DEALER SERVICE BULLETIN JANUARY 2009 REPLACEMENT REMOTES

Dealer Service

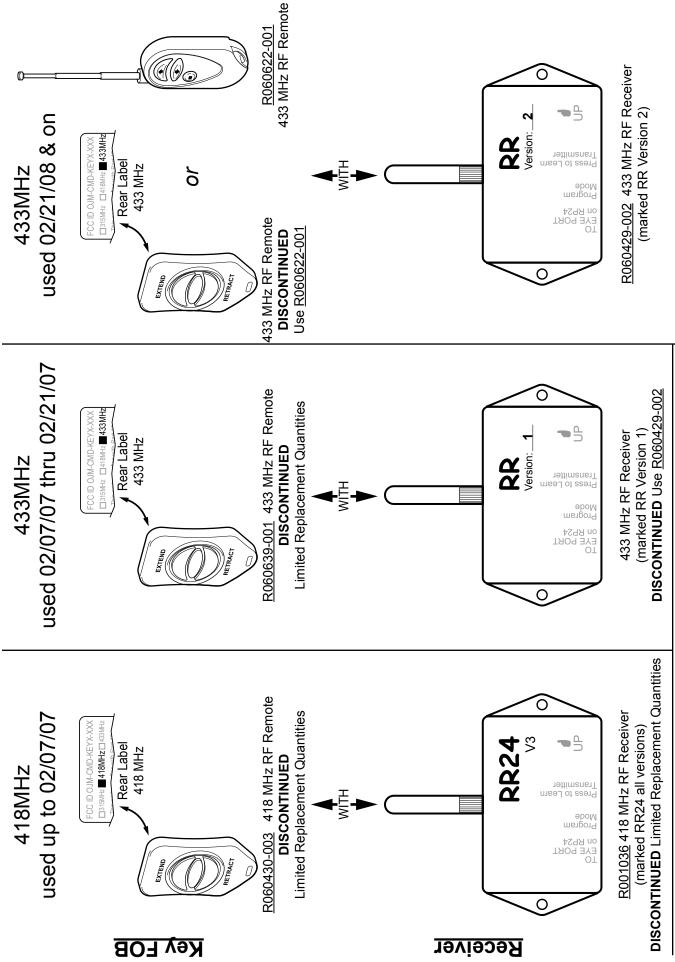
Remotes: Gray button key FOBS marked 433 MHz - limited quantities available. When stock
is depleted it will be necessary to upgrade to the latest 433 MHz configuration; use SR0014, kit
contains receiver and key FOB.

NOTE: The 433 MHz key FOB (with antenna) does not work with the RR version 1 receiver. It will be necessary to replace the receiver and key FOB.

• Receivers: Receivers marked "RR version 1" are discontinued and unavailable. Use R060429-002 marked "RR version 2".

NOTE: The RR version 2 receiver is compatible with both the gray button 433 MHz key FOB and the key FOB w/ antenna.

- Remote: R060622-001 433 MHz key FOB w/ antenna.
- Receiver: R060429-002 433 MHz receiver marked "RR version 2".

To update the remote to the latest 433 MHz configuration, order SR0014. Kit contains one (1) R060429-002 Receiver and one (1) R060622-001 Key FOB
